ADDENDUM No. 2

**DOBBS BRANCH BASIN IMPROVEMENTS PHASE 1
CONTRACT NUMBER W-17-022-201**

CITY OF CHATTANOOGA, TENNESSEE

C - 506

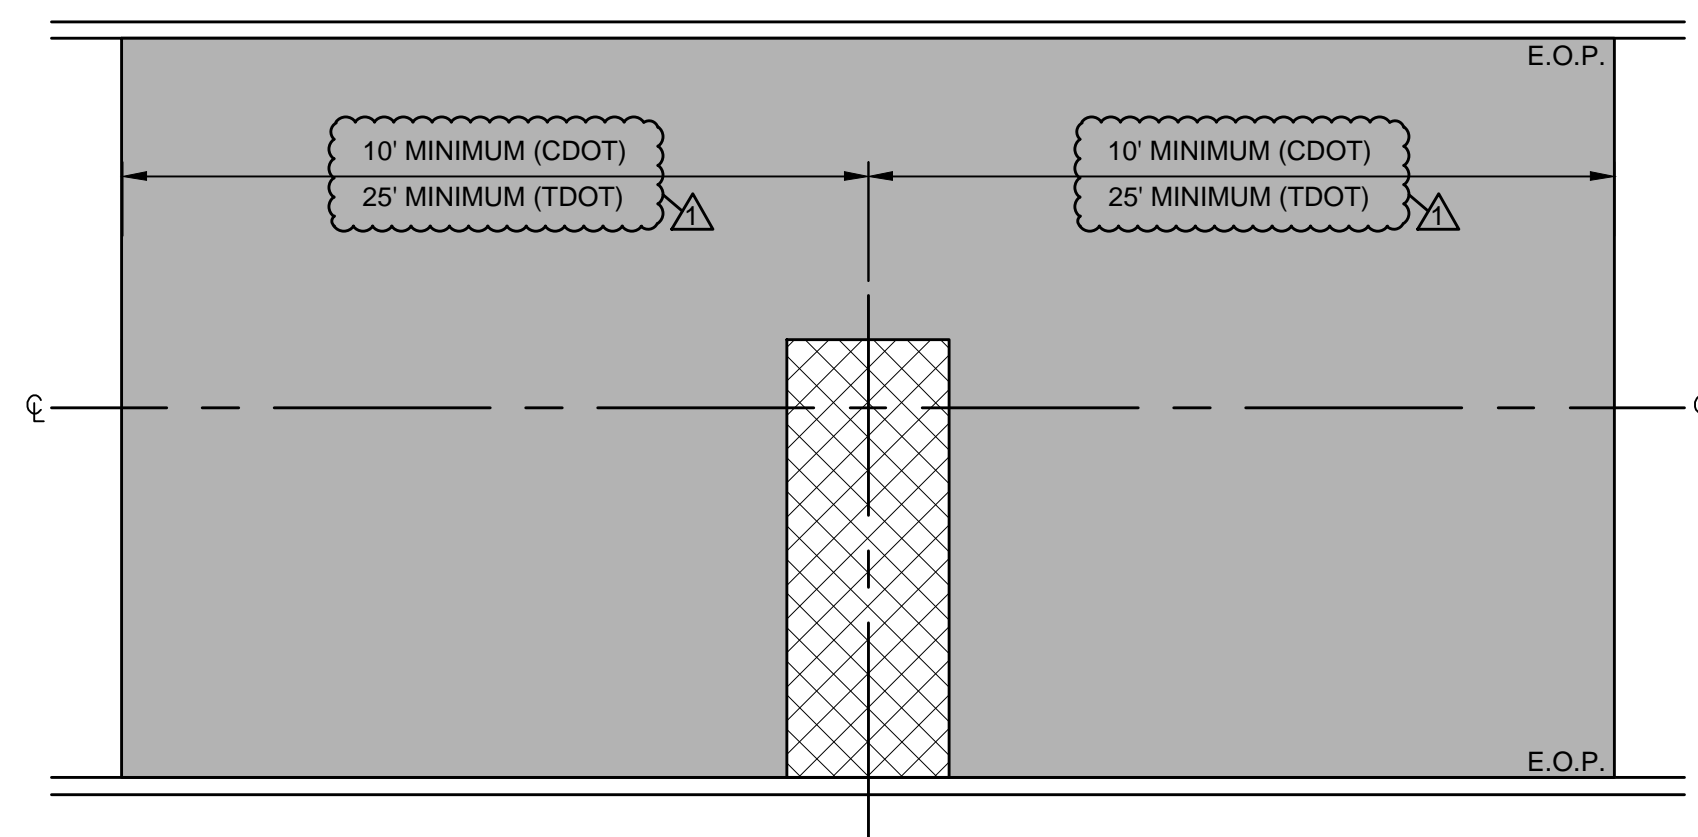
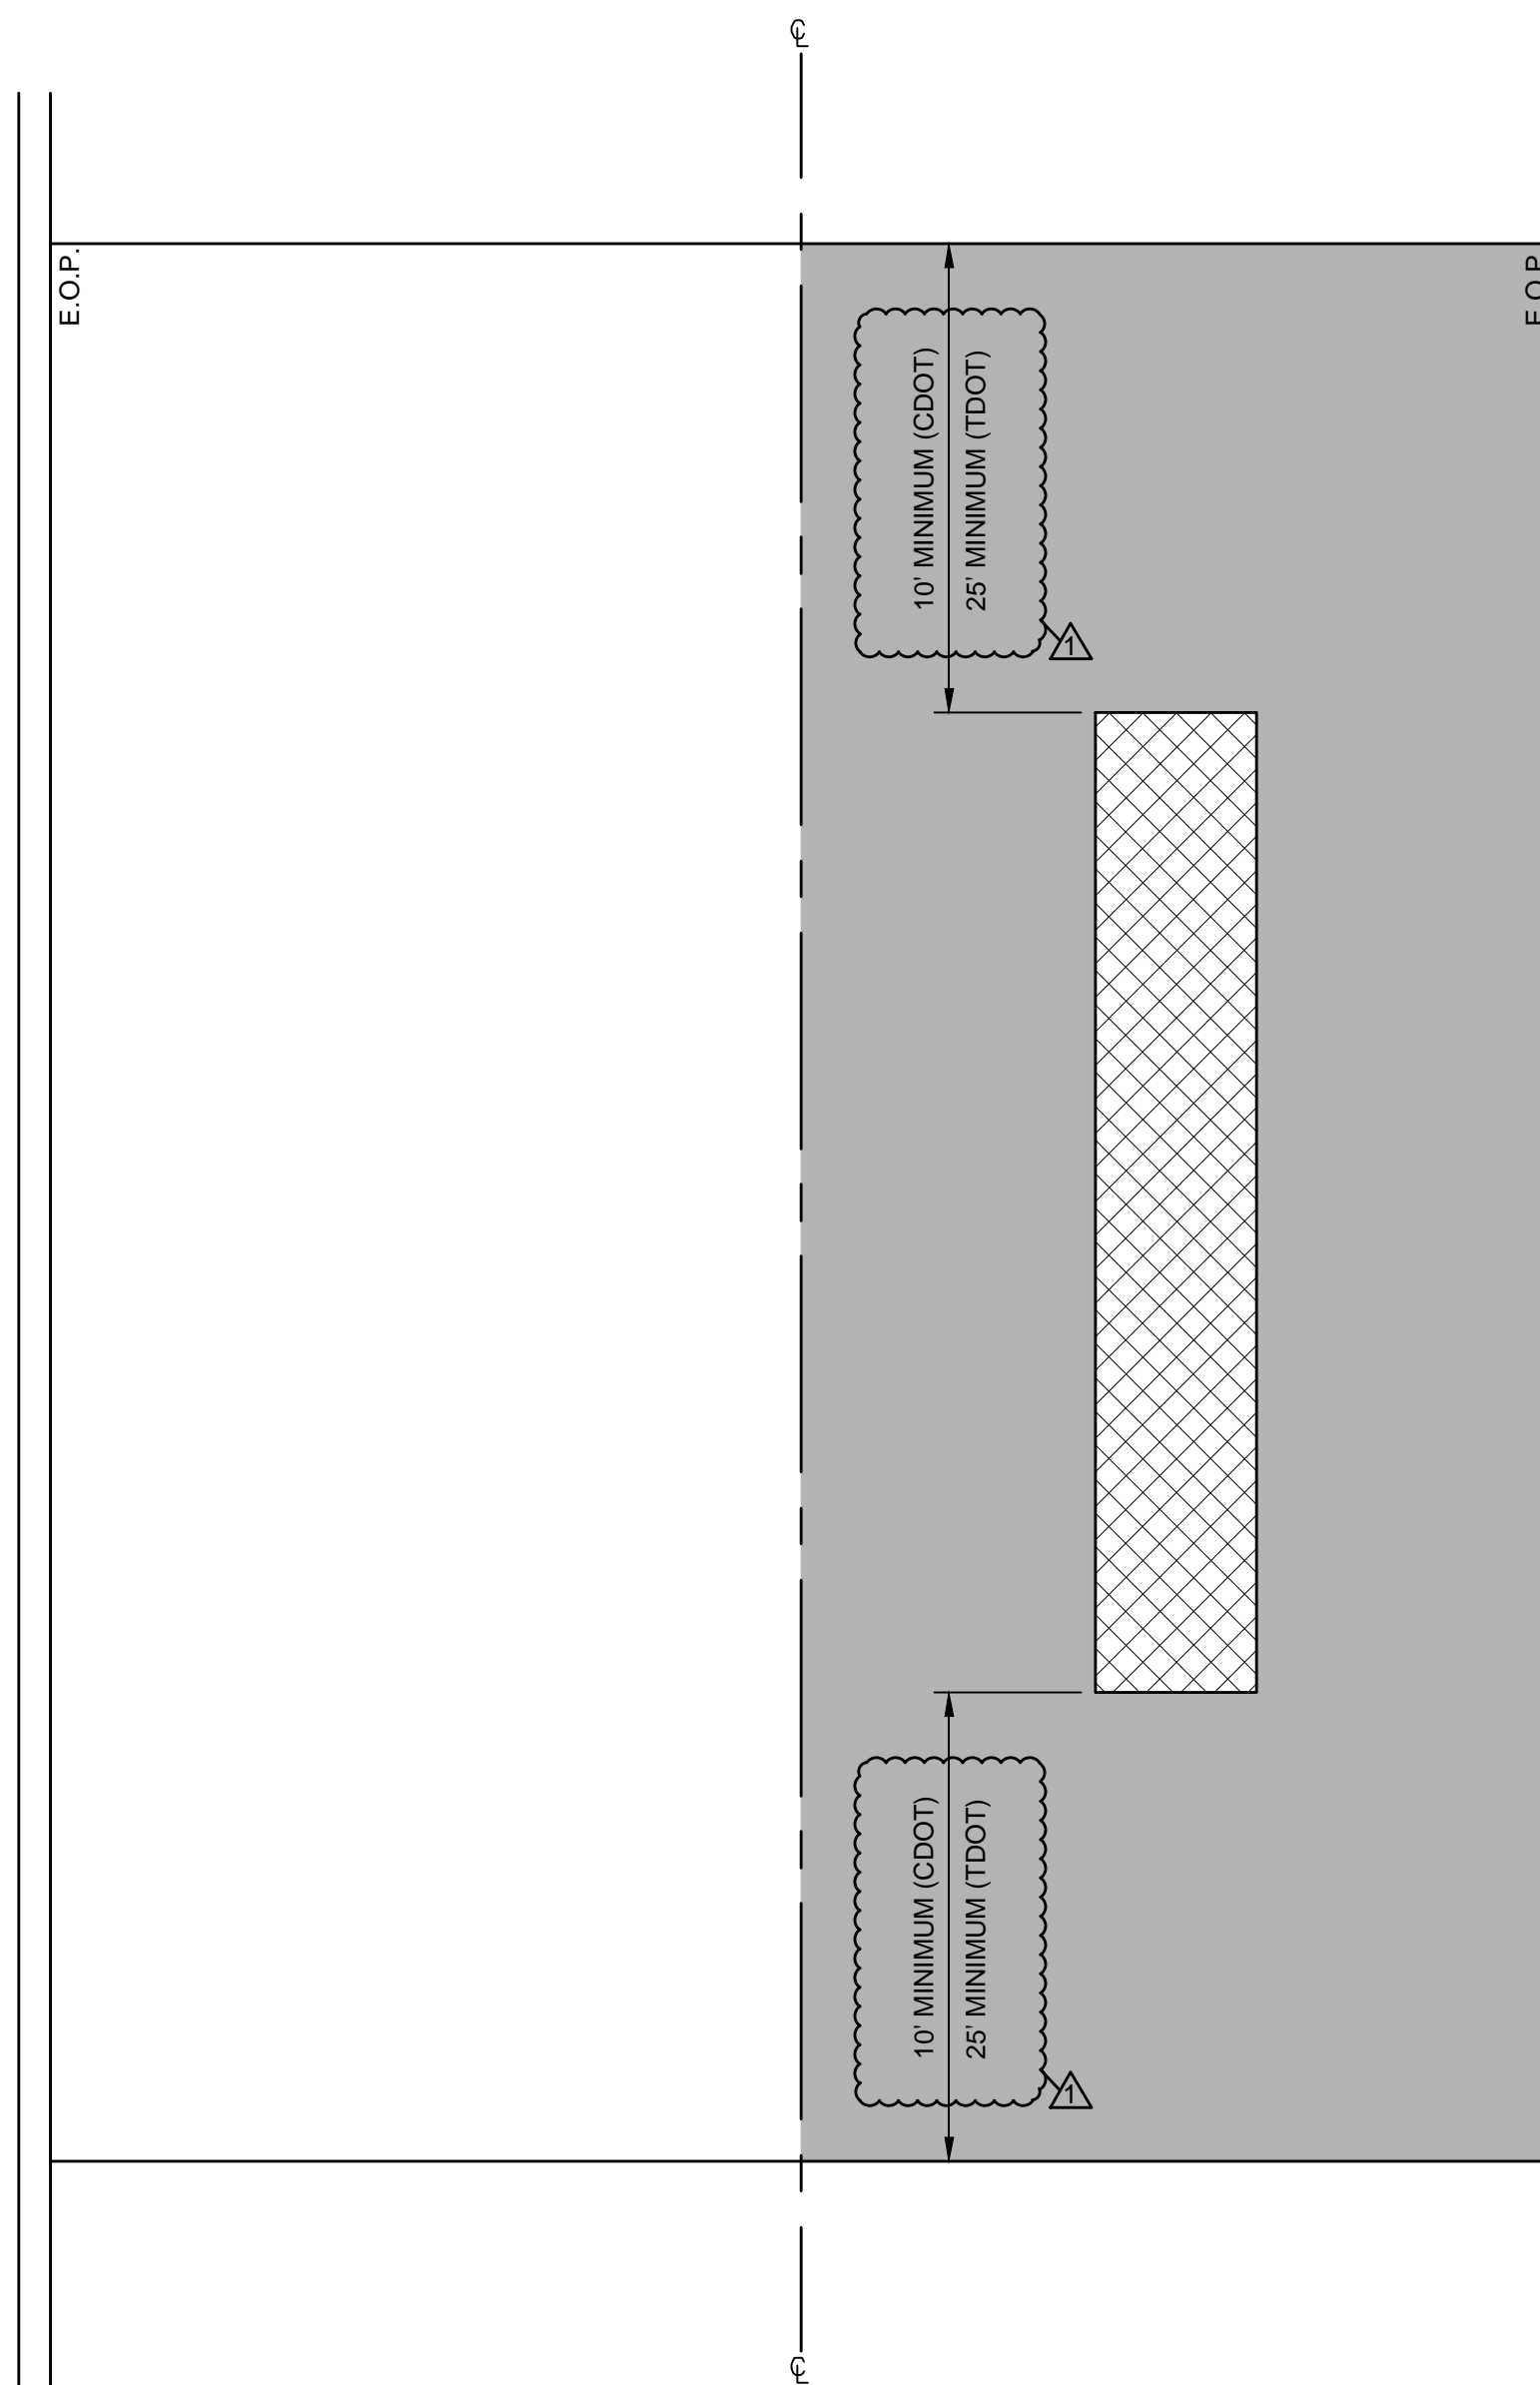
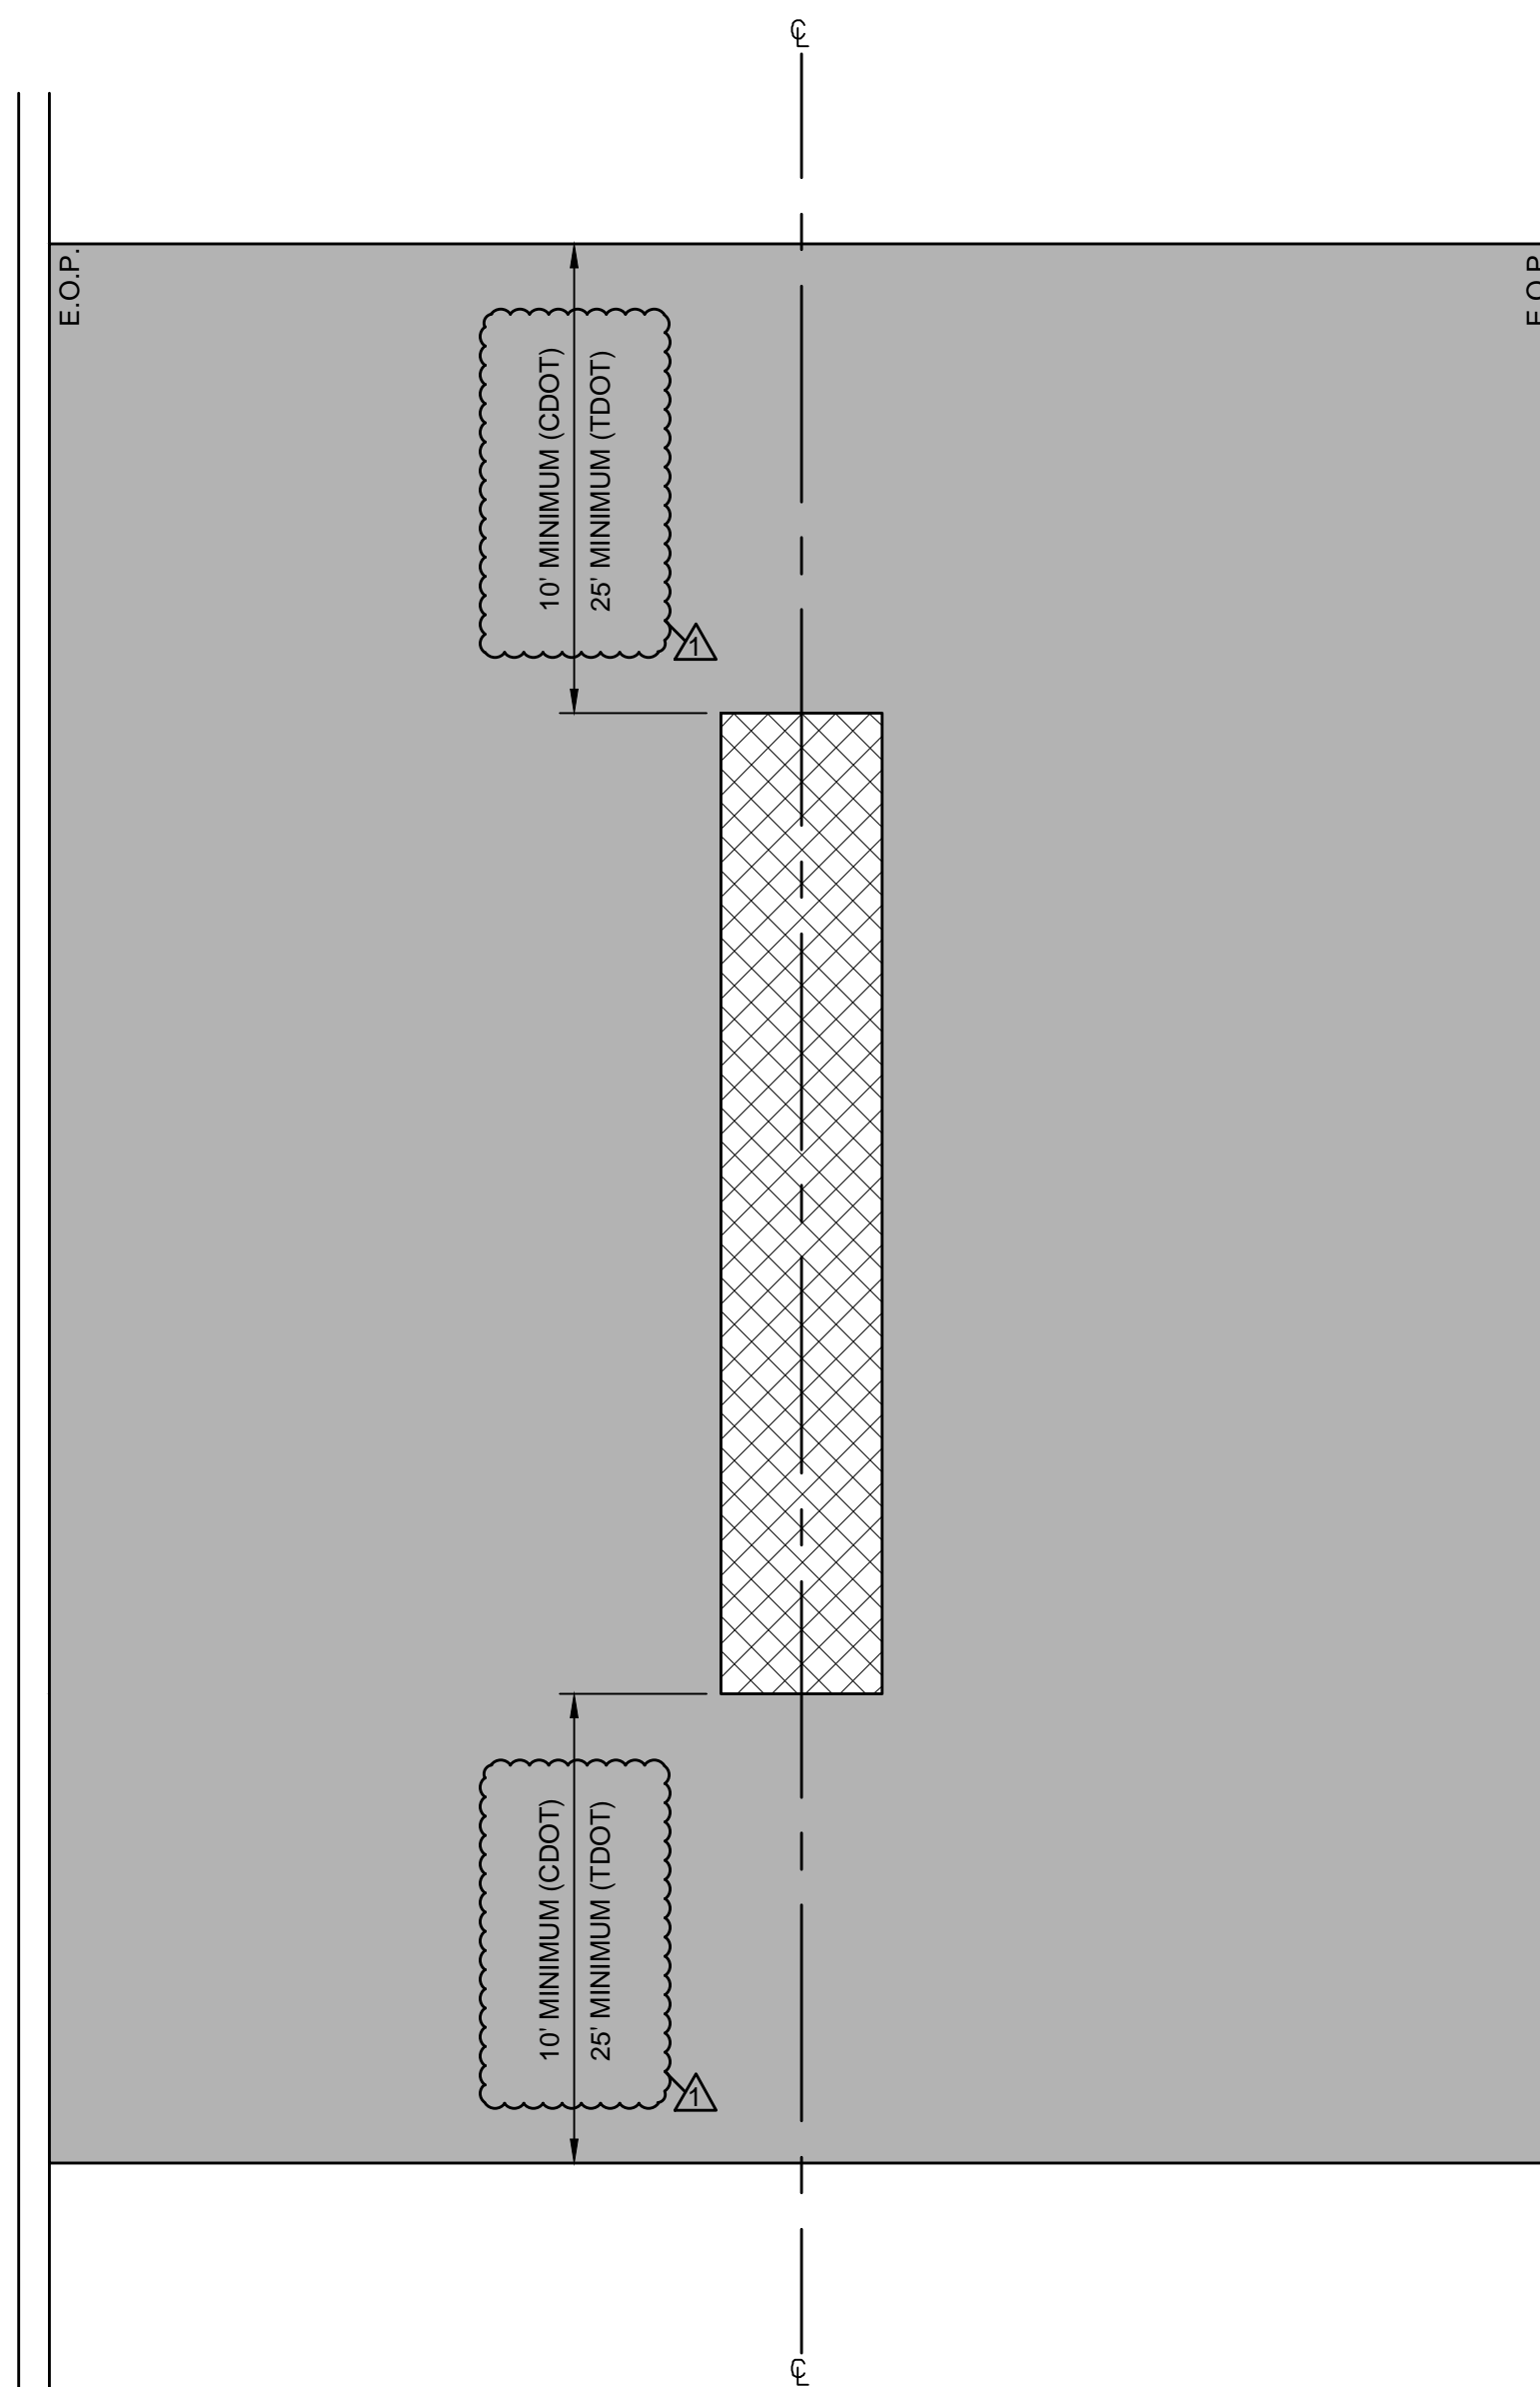
5. Contract Drawing C-506

Delete C-506 and replace with the attached revised drawing.

Q5: Is there a different standard for TDOT roadways versus City streets for the asphalt milling and paving item in the specification?

R5: Yes. See revisions to Drawings C-506, C-507 and Section 01 22 00 via addendum.

1. ANY PERPENDICULAR CUT IN A ROADWAY MUST BE REPAVED NO LESS THAN THE FULL WIDTH OF THE TRAVEL LANE(S) THAT IT CUTS, AND A MINIMUM OF 10' ON EACH SIDE OF THE CENTERLINE OF EXCAVATION.

1. ANY LONGITUDINAL CUT MUST BE REPAVED NO LESS THAN THE FULL WIDTH OF THE TRAVEL LANE(S) THAT IT CUTS EXTENDED NO LESS THAN 10' BEYOND THE BEGINNING AND END OF THE CUTS BEING MADE.
